NUCLEAR REGULATORY COMMISSION

Title: Advisory Committee on Reactor Safeguards
 ESBWR Subcommittee: OPEN SESSION

Date: Tuesday, June 22, 2010

Open Item 5.4-59

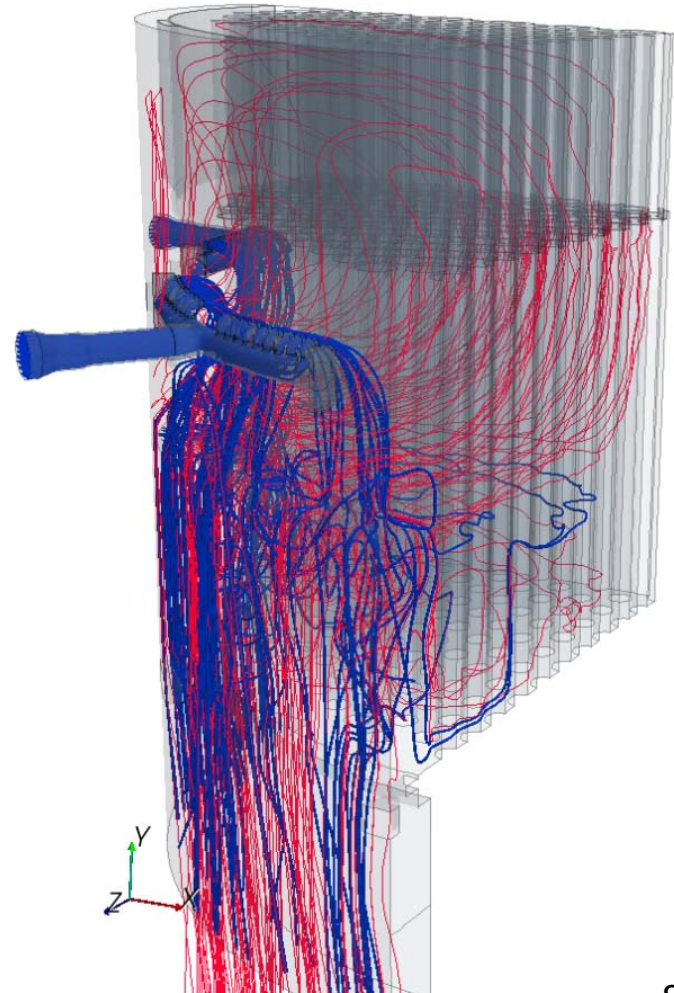
3 I included this figure to help clarify
4 the actual conditions during cooling. Basically we
5 have steam separators which are in red and, in
6 particular, the separators themselves or the upper
7 part here, this is the area that actually separates
8 steam and turns it back into reactor fluid. It has
9 several exit points along the way and then the one at
10 the bottom is what we point to as the lower exit
11 point for returning flow.

2 MR. DEAVER: Okay. So let's move to the
3 next slide then. Okay. So there were basically two
4 issues we were addressing. One was the circulation
5 path which was in Response A here. We talk about the
6 vertical separation of feedwater flow and the
7 returning flow. We did a number of sensitivity
8 studies to check to see what the affect would be if
9 we didn't get complete mixing and we found we had a
10 lot of margin associated if we had any complete
11 mixing at different flow rates.

- Mass flow from separator spillover (red) is over 10X the mass flow from the spargers (blue) at 8 hrs.
 - The spargers physically spread the incoming flow around the periphery of the vessel.
 - The incoming flow (blue) is swept away by the significantly larger natural circulation flows coming out of the separators (red).
 - Mixing is nearly 100% and bypass is not predicted.

Normal power to UPS is from Isolation Power Center bus

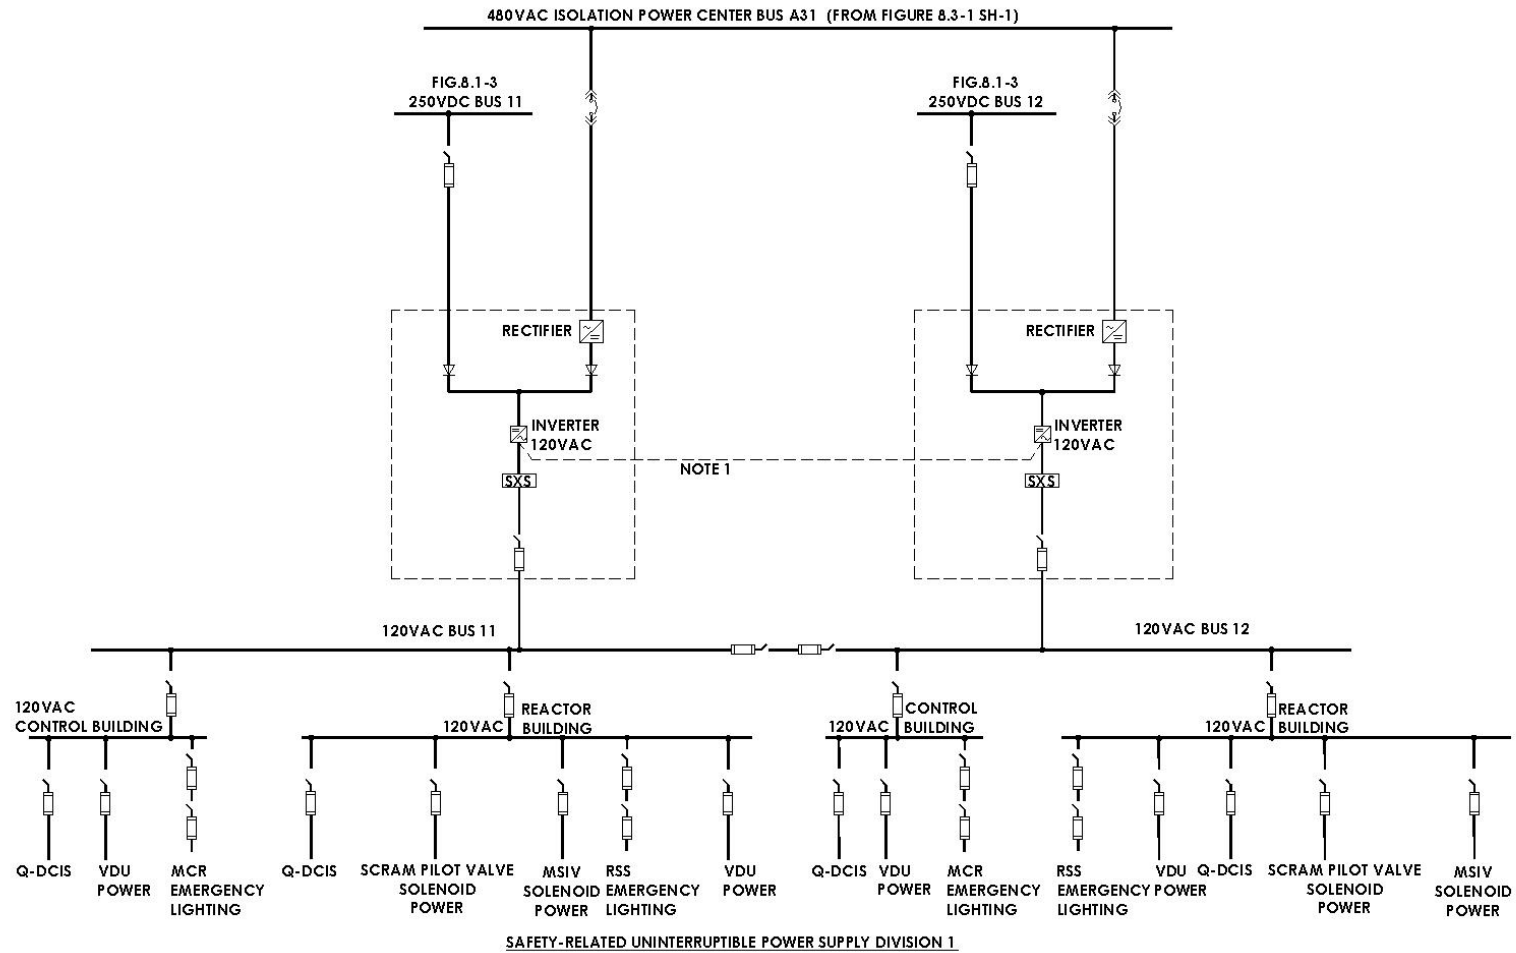
13 MR. STRYHAL: Okay. This is John
14 Stryhal, GEH. The in-volt voltages that could
15 interrupt the inverter could come in through both the
16 battery chargers for the two batteries or through the
17 two inverter rectifiers which are just like battery
18 chargers on other plants.

17 MR. WACHOWIAK: One of the things John
18 was talking about on this system was the battery
19 charger. This figure does not show the battery
20 charger so just in case there was any confusion about
21 that it's not on here.

No safety-related UPS bypass transformers to preclude the potential for disruptive voltages and frequencies to reach safety-related loads

Ancillary Diesel Generators (ADG)

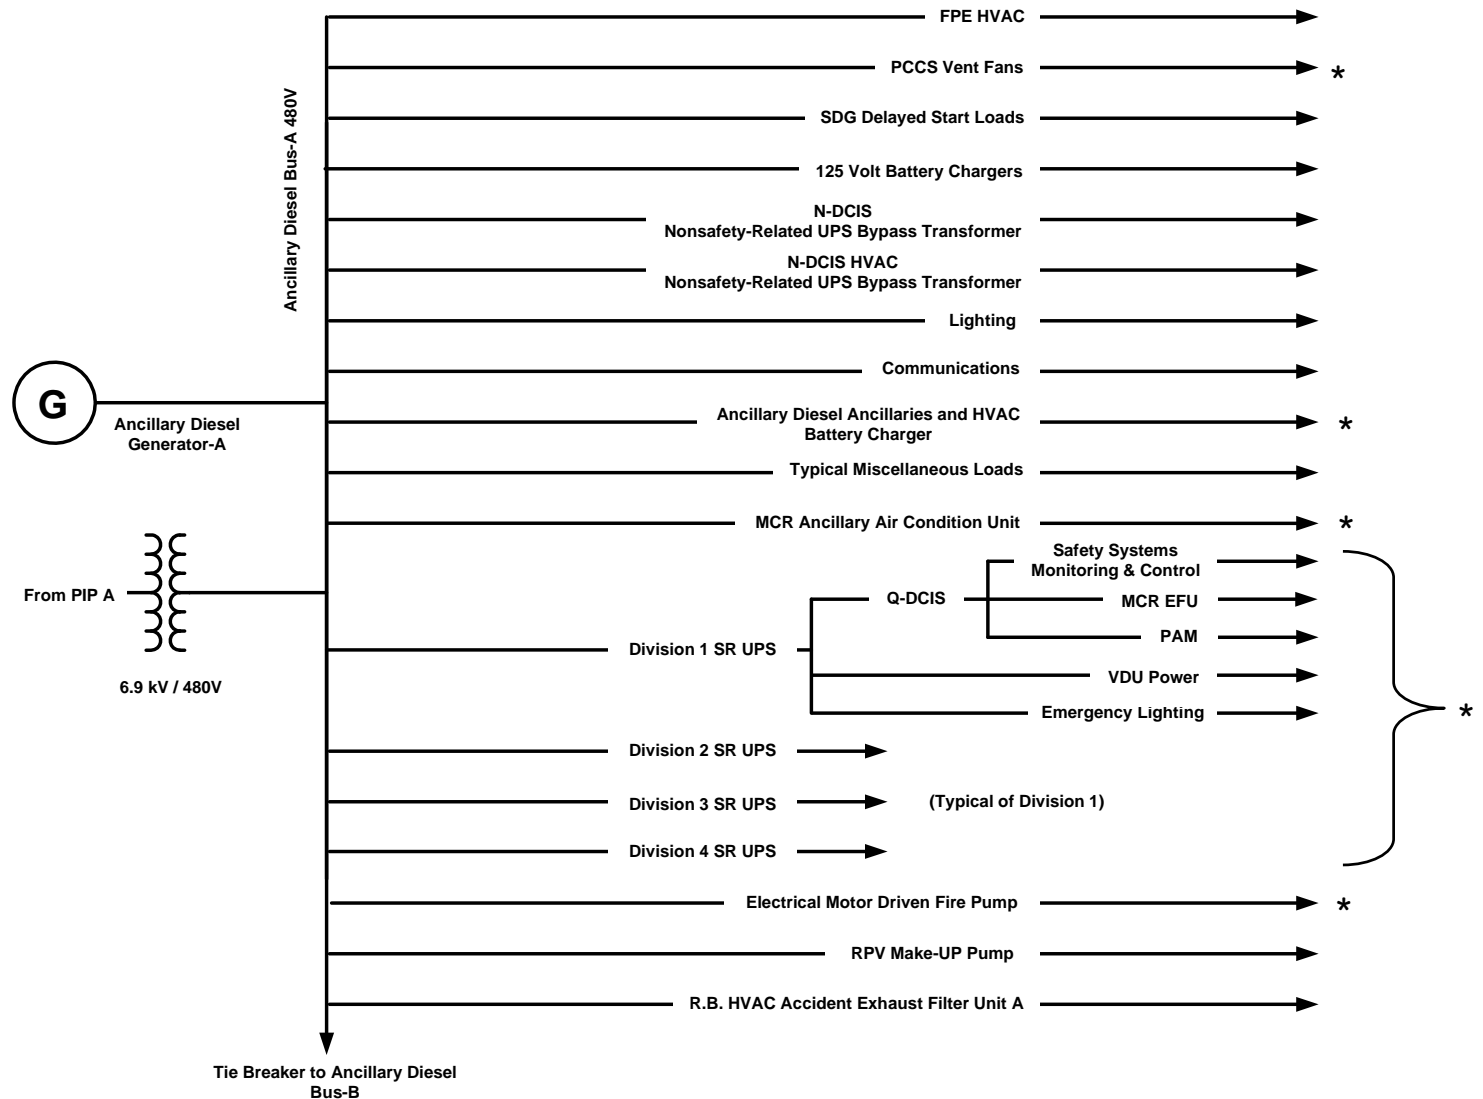
21 Hard to read on here. I think they are
22 easier to read on your actual printed copies. Sorry
23 not for the people in the back with the multiple-page
24 ones but this figure is essentially in the DCD.

1 buses are provided by either one. I've shown one
2 here but the other generator would be connected to
3 essentially the same bus. We have normal power
4 coming in from the PIP system and PIPV comes on the
5 other side. You'll notice here that I have some of
6 the loads marked with a star. Those are the loads
7 for a RTNSS that actually brought us to needing these
8 generators. We've got, as I mentioned, the PCCS vent
9 fans, the auxiliaries for the generator itself, the
10 main control room HVAC. They provide a backup power
11 for Q-DCIS and you can see all the different things
12 that come under Q-DCIS. All four divisions can be
13 powered by these. We do have an additional pump that
14 used to be in the design, a diesel-powered pump. I'm
15 sorry, move back up. That is a different one. We
16 took credit for our two fire pumps, the diesel fire
17 pump and the electric fire pump and the electric fire
18 pump is provided by this diesel generator.

9 MEMBER STETKAR: You know, if I were an
10 attorney I would understand that answer. If I'm an
11 engineer I don't understand the answer because these
12 diesels are important to safety. They are RTNSS
13 equipment. They are not insignificant in terms of
14 the overall plant.

Typical P&ID (Figure 11.2-1a)

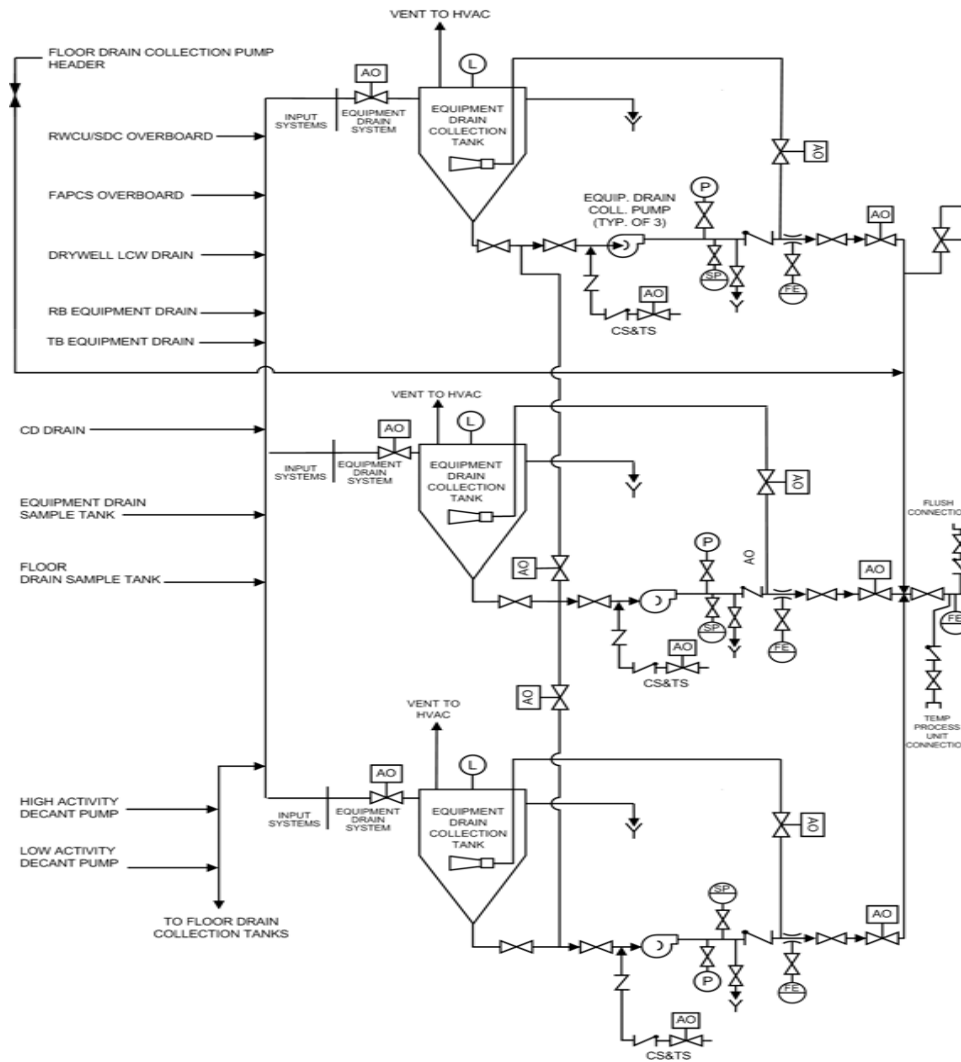
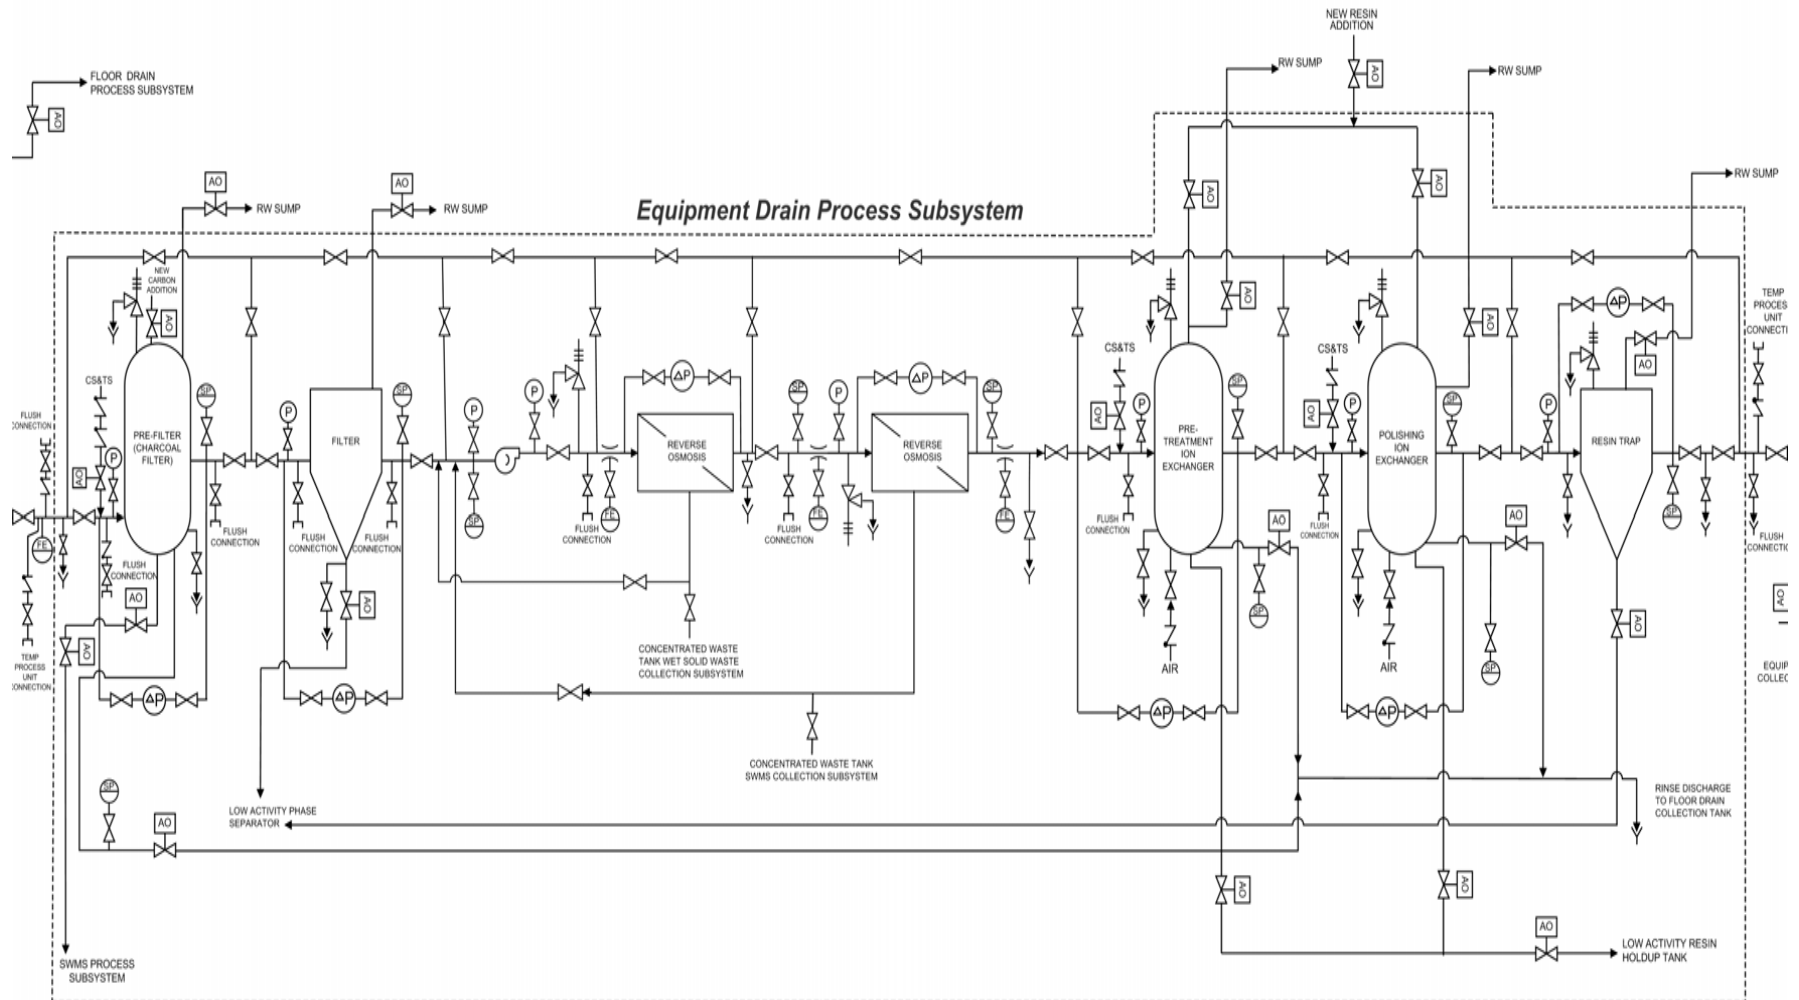
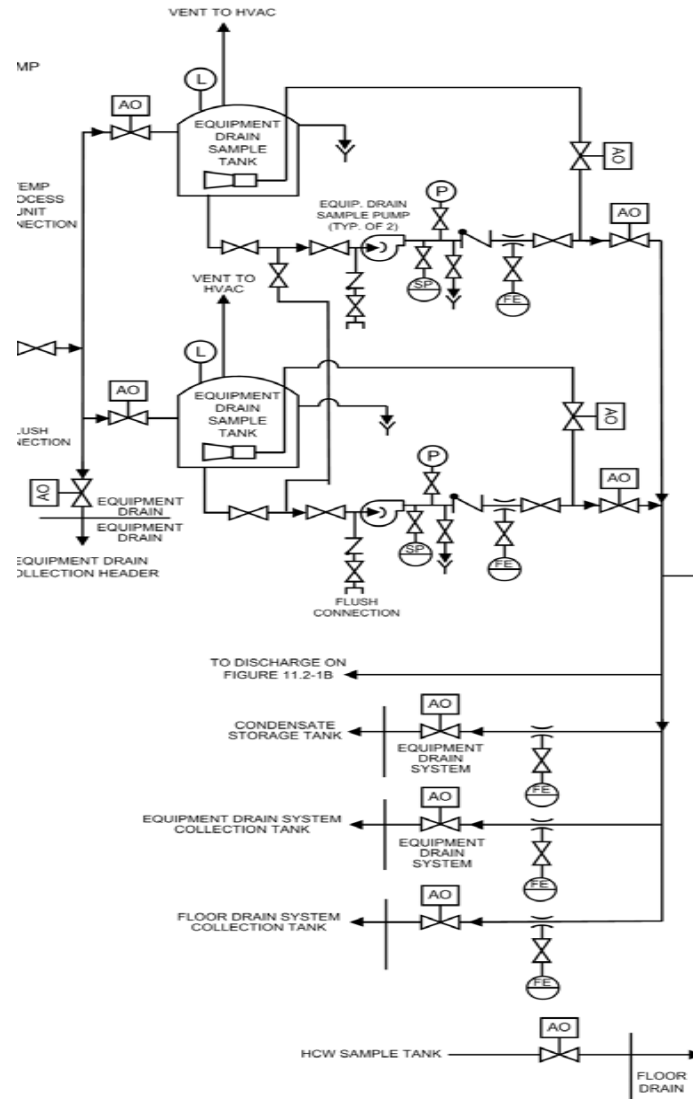
21 Now, this is just a typical P&ID that we
22 have added. All the P&IDs are in the Chapter 11. I
23 understand it's tough to read and I didn't expect you
24 to be able to read it. I just wanted to show the
25 level of detail that we have in the chapter now.

13 MEMBER RYAN: On this level all of the
14 equipment that we are looking at in this drawing is
15 skid mounted?

2 MEMBER RYAN: I appreciate that you are
3 saying that you want to have the ability to change
4 systems out over a lifetime of a plant because
5 radwaste does evolve over time. I'm trying to just
6 get a feel for if 30 years from now I decided I
7 needed a whole new set of skids how much floor space
8 am I getting by removing all this?

- As a result of RAI 11.2-16, DCD Subsections 11.2.2.2 and 11.2.2.3 and Figures 11.2-1a, 1b, 3 and 4 were revised accordingly.
- As a result of RAI 11.4-18, DCD Subsections 11.4.2.2 and 11.4.2.3 and Figures 11.4-2 and 11.4-3 were revised accordingly.
